Service Bulletin

REF 03-06

REPLACEMENT FEELER ARM FOR INTEGRATED ICE™ MODELS

Feeler Arm

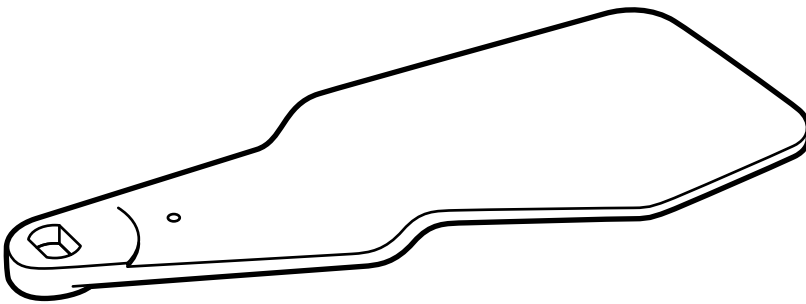
Consumer calls for slow ice or too little ice on GE and Profile side-by-side refrigerators with the Integrated Ice™ system (inclined bucket) can be resolved using the new feeler arm WR49X10139.

The new feeler arm is designed with a raised step to allow the icemaker to produce additional cubes prior to cycling off on a full bucket. The additional capacity improves the dispensing characteristics of the inclined bucket.

Replace the feeler arm using the spring and screw from the existing arm.
